ULNRC-04353

**DOCKET NUMBER 50-483
CALLAWAY PLANT
UNION ELECTRIC COMPANY
OPERATING LICENSE AMEMDMT REQUEST:
"UNREVIEWED SAFETY QUESTION REGARDING
INSTALLATION OF LOAD TAP CHANGING TRANSFORMERS TO
PROVIDE OFFSITE POWER TO THE SAFETY RELATED ELECTRICAL
BUSES"**

DESCRIPTION OF PROPOSED CHANGES AND ASSESSMENT

Figure 1
LTC and Capacitor Bank Voltage Control

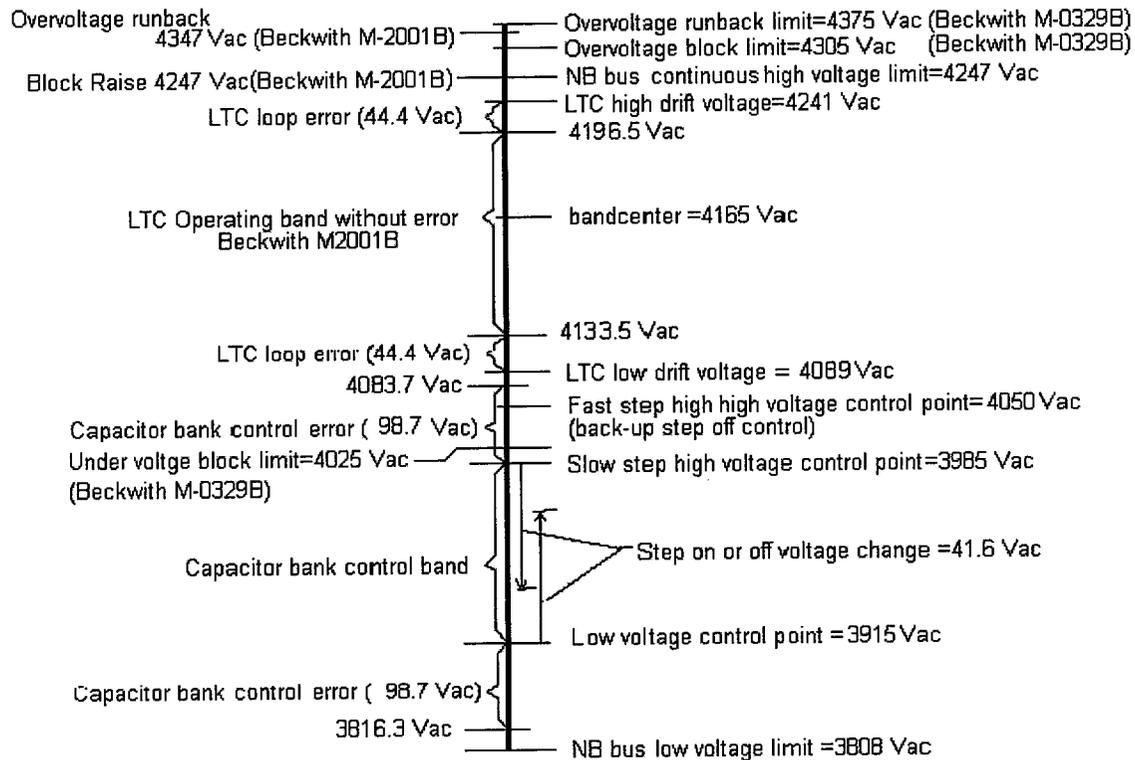
The control of the tap changer will be automatic, based on the secondary voltage of the transformer. The control circuits will be designed to limit the probability of either an under voltage or over voltage failure by using a Beckwith M-2001B primary controller and Beckwith M-0329B backup controller. The Beckwith 2001B is set to control the secondary voltage at $4165 \pm 31.5V$. The Beckwith M-0329B backup relay will block tap changer signals to raise voltage if the secondary voltage is above 4305V and create a tap changer signal to lower voltage if the secondary voltage is above 4375V. The Beckwith M-0329B backup relay will block tap changer signals to lower voltage if the secondary voltage is below 4025V. The first tap change will take a minimum of 2.5 seconds with subsequent steps taking about 2 seconds. Each step will vary the NB bus voltage by approximately 1%. The control settings in Figure 1 are established by load-flow analysis.

With both systems in operation, the general response to a LOCA is for the capacitor bank to provide a rapid voltage increase if needed and then the LTC will step to correct the voltage back to a 4.16 kV level and thus turn the capacitor bank off. The voltage control systems function to ensure that the voltage at NB01 and NB02 is sufficient to reset the safety related degraded voltage relays and loss of voltage relays before time limits are exceeded. With this, the preferred off site power sources are retained to power the safety related electrical distribution system. The voltage control systems also function to ensure that overvoltages are not present in the safety related electrical distribution system when fed from the preferred power sources.

MAIN SINGLE LINE DIAGRAM
 CALLAWAY PLANT
 UNION ELECTRIC COMPANY
 ST. LOUIS, MO

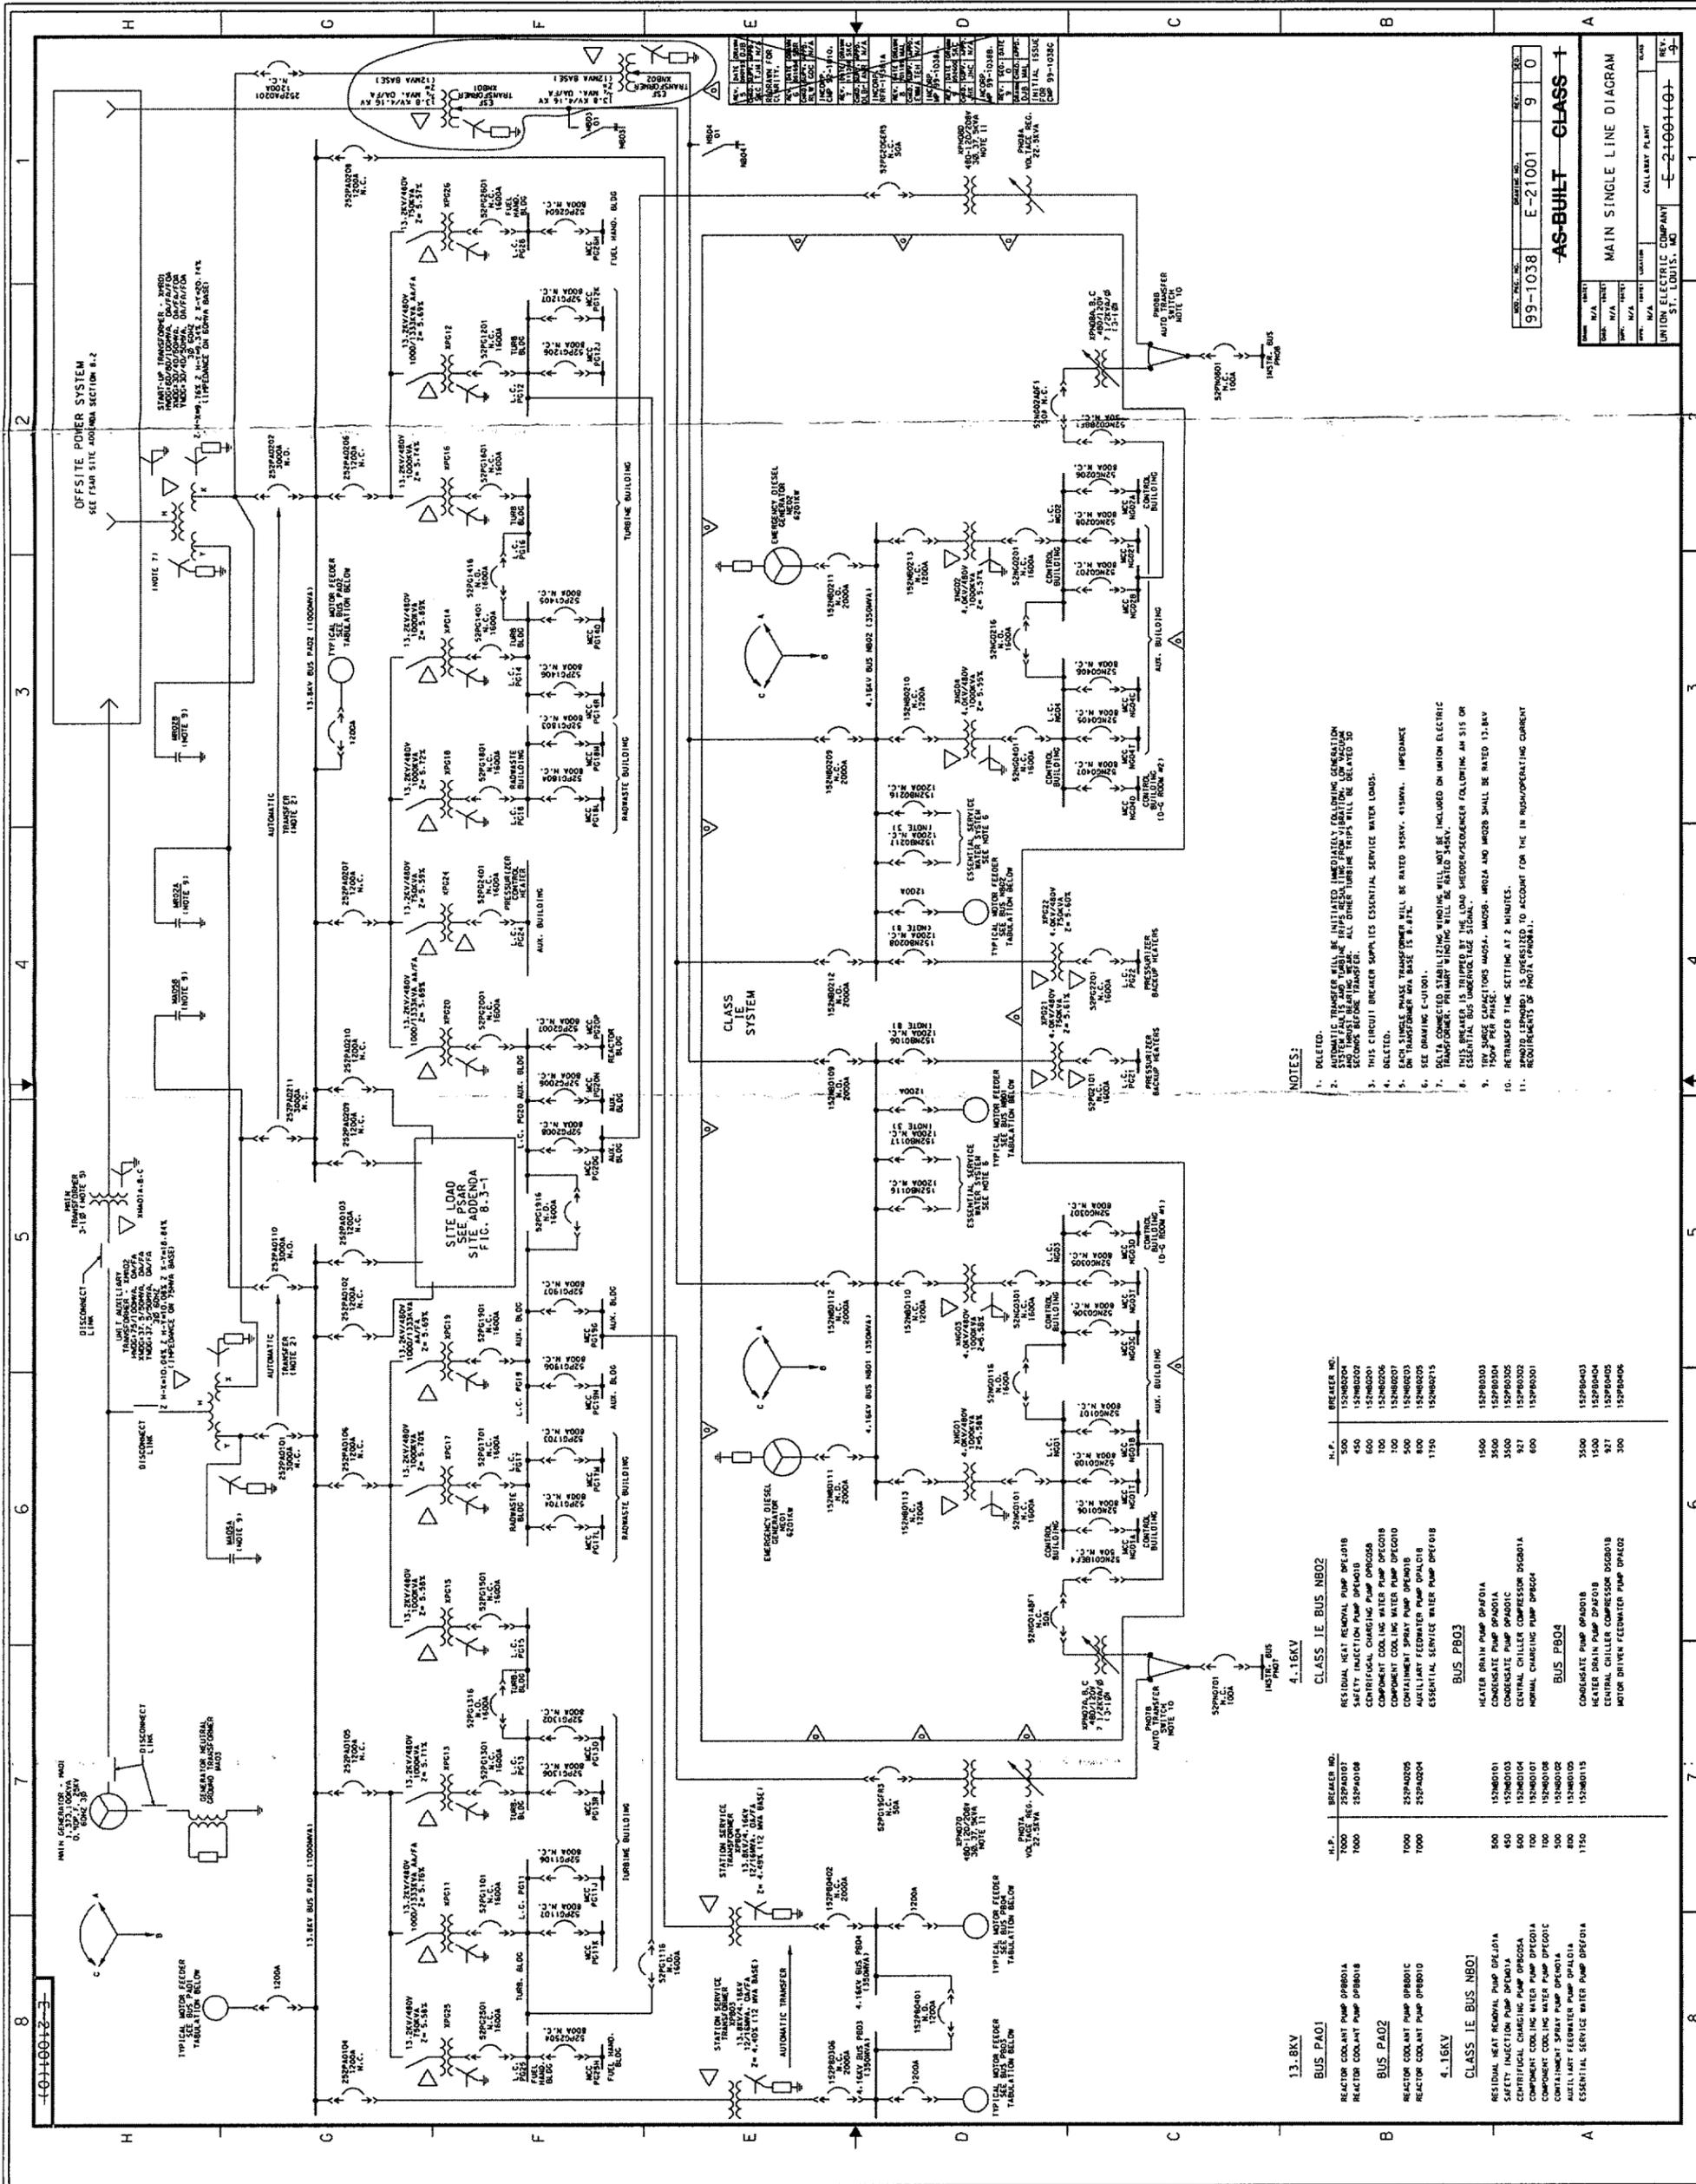
12/22/00
 FEAR CN 00-095

and associated automatic load tap changer Δ
Each ESF Transformer is rated 12/16-MVA and has adequate capacity to supply the maximum loads of both safety-related systems simultaneously during normal and abnormal operating conditions, accident conditions or plant shutdown conditions. Their associated capacitor banks provide voltage correction for the NB busses if required.

CALLAWAY PLANT
 FIGURE 8.3-3
 LOGIC DIAGRAM STANDBY GENERATOR
 EXCITATION CONTROL
 (E-22400)
 REV. 01-85
 0794/11/01

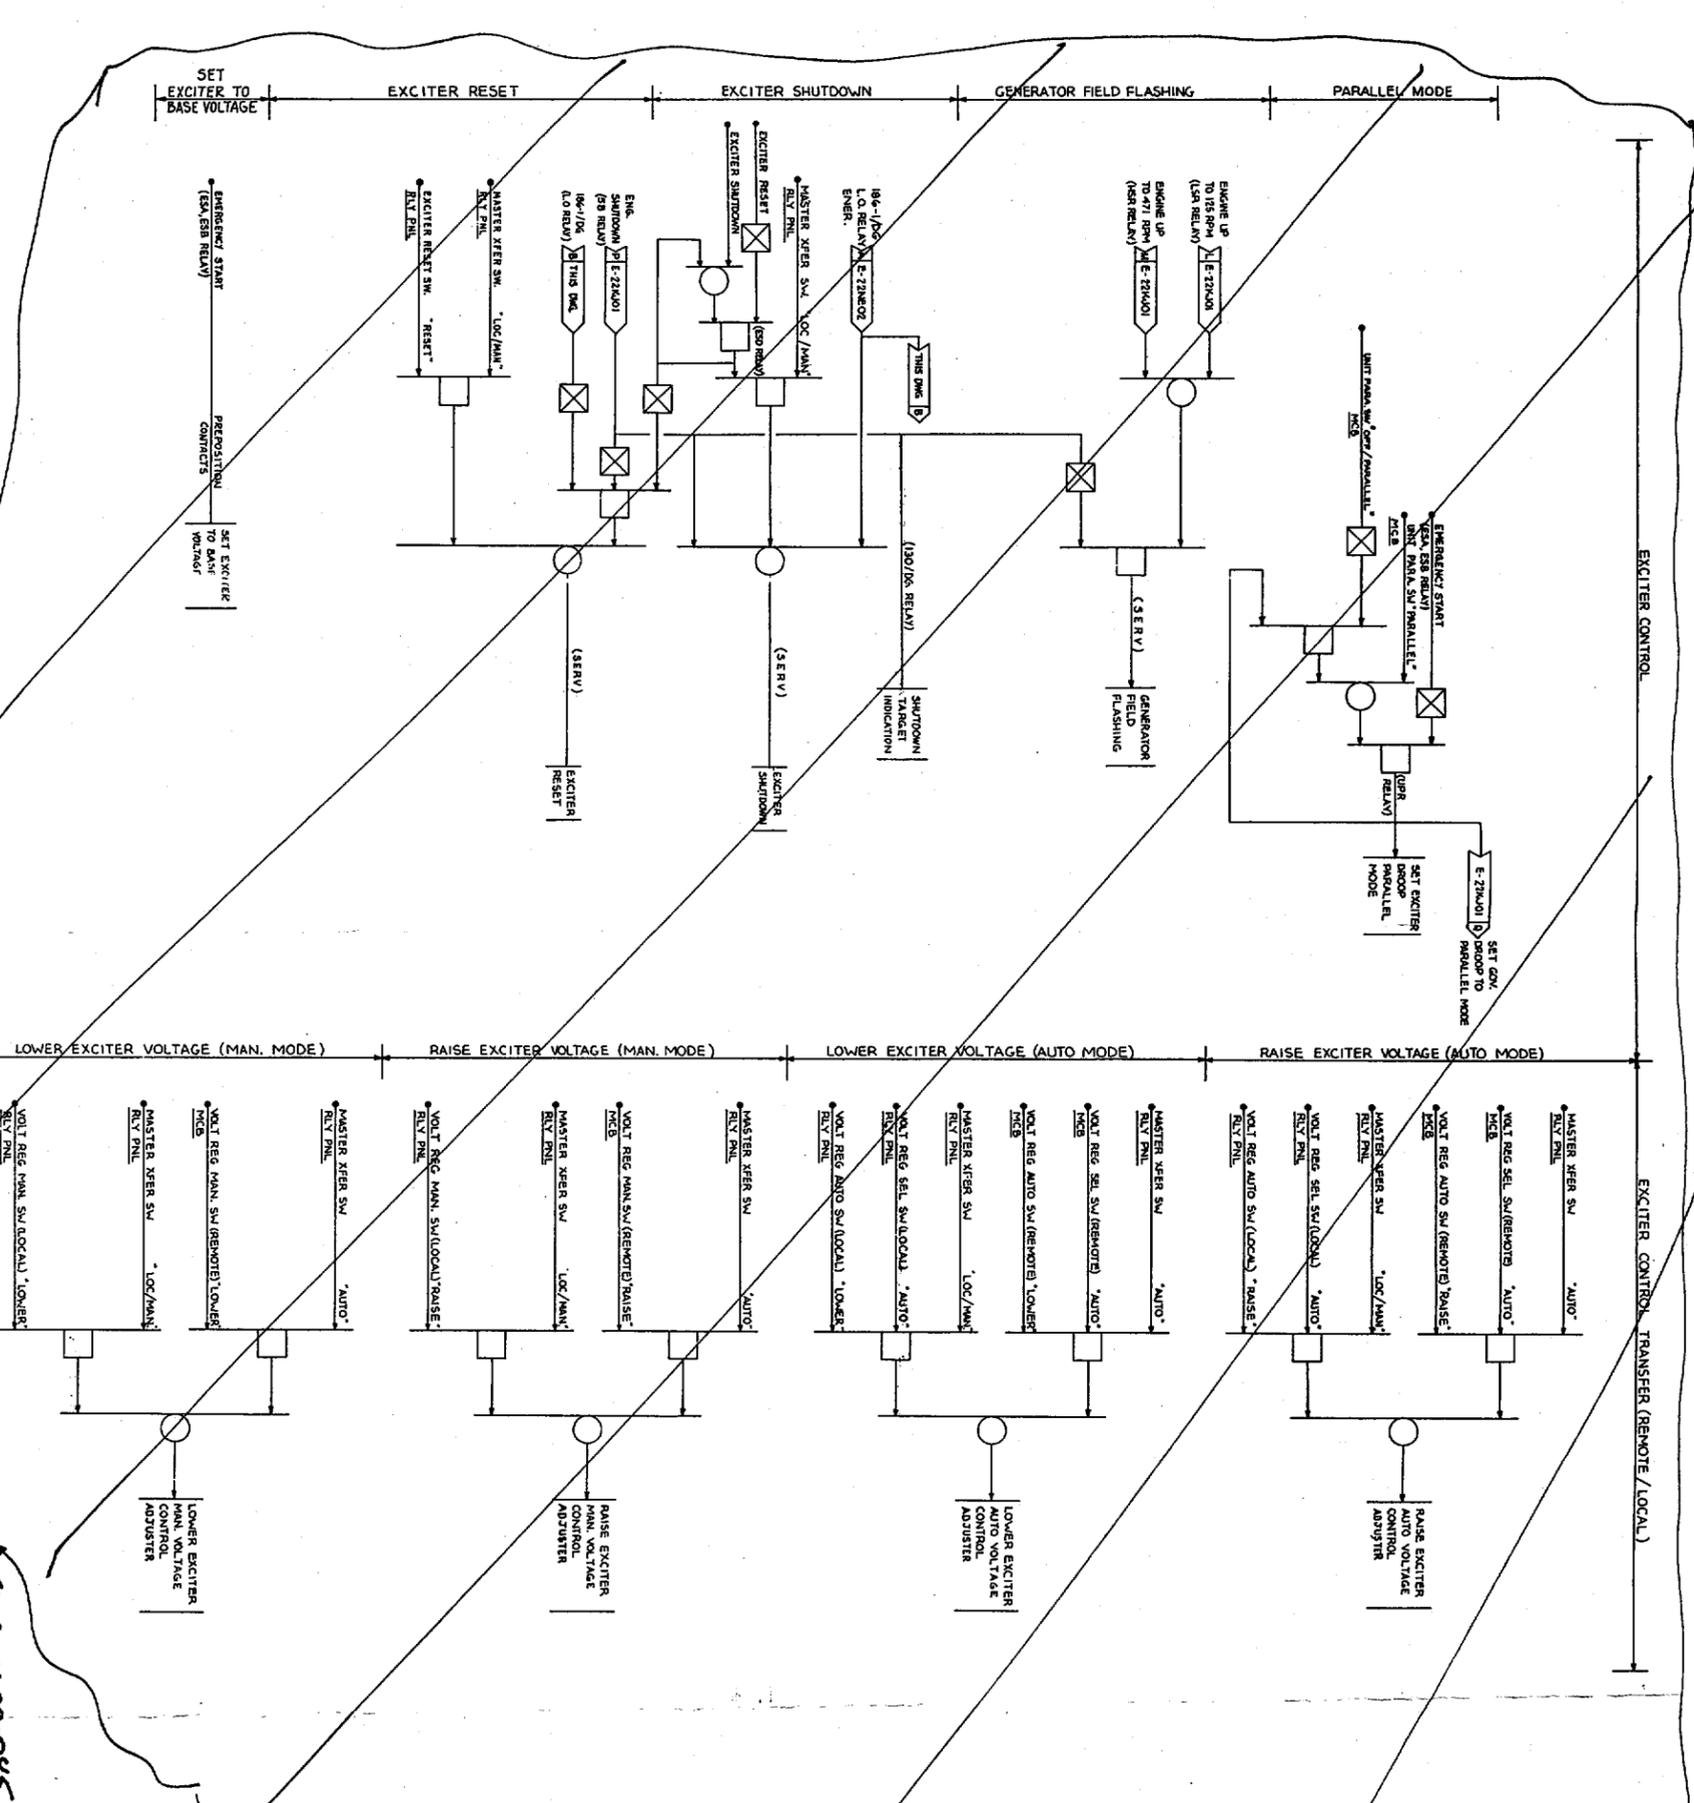
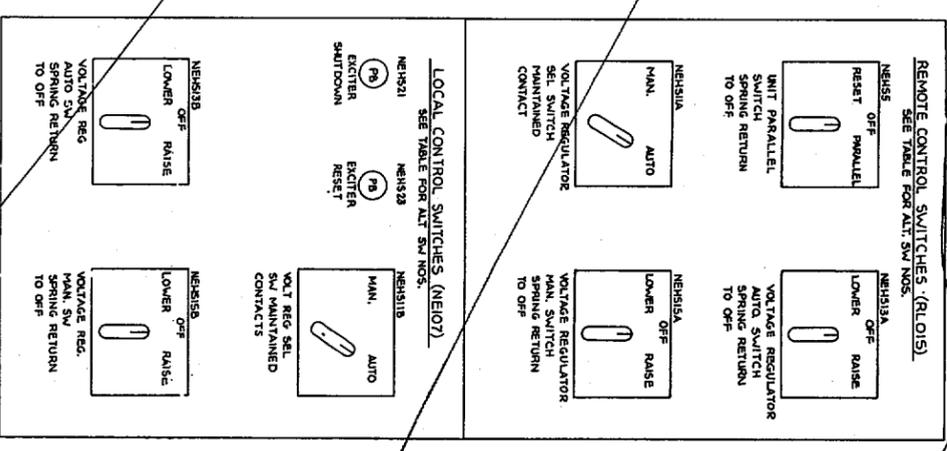
FSAE CW 00-045
 W/M 12/10/00
 SEE MOD DRAWINGS
 99-1038 E-224001-2
